Addendum #2

Date: March 16, 2016
Project: University Courtyard Building #4 Improvements
Contract: FD-15-045

INTERIOR RENOVATIONS
DELAWARE STATE UNIVERSITY
UNIVERSITY COURTYARD SUITES BUILDING #4
DOVER, DELAWARE
COMMISSION NO.: 15U014

UNIT A - KITCHEN ELEVATION

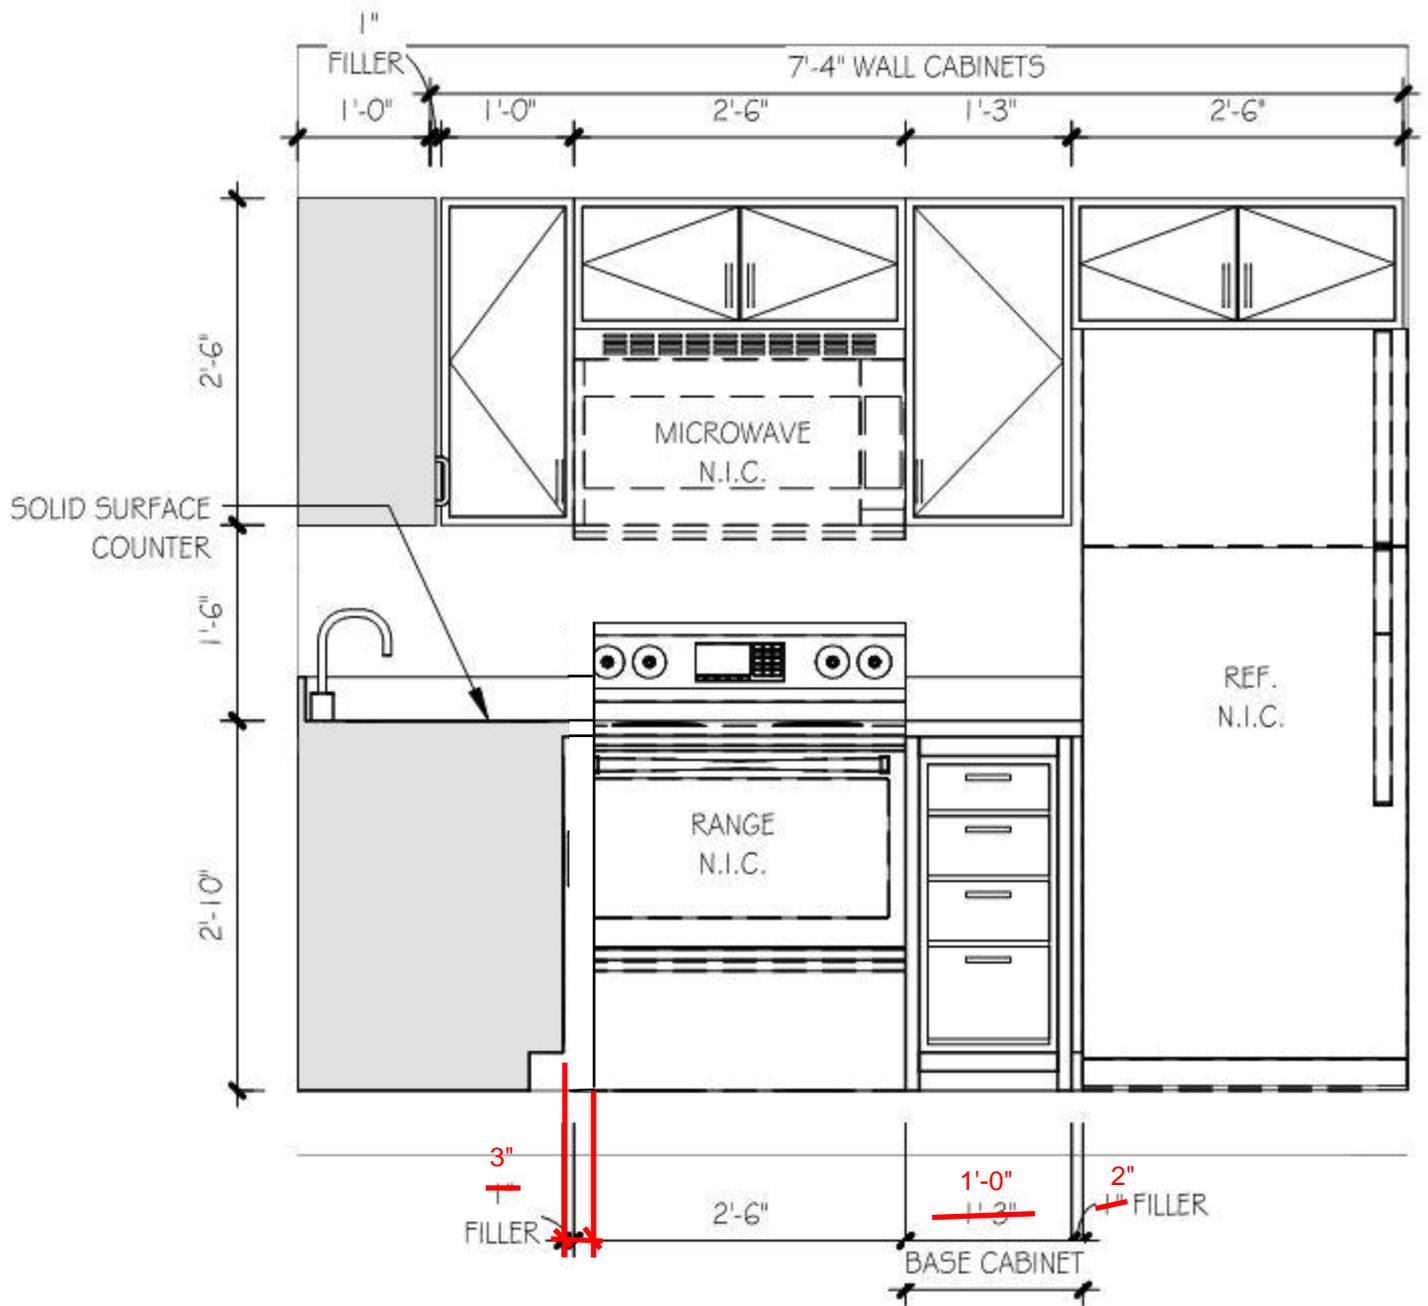
16. **Question:** On the A units there is a conflict with the stove and the run of cabinets perpendicular to the stove. The stove door will hit the cabinet door and door pull when opened. Please advise.

Answer: We should locate a spacer to the left of the range so that the oven can open without hitting the pulls on the cabinets that are perpendicular to the oven. The cabinet to the right of the oven will then be 12" wide instead of the 15" wide shown on the drawings. Please see attached sketch.
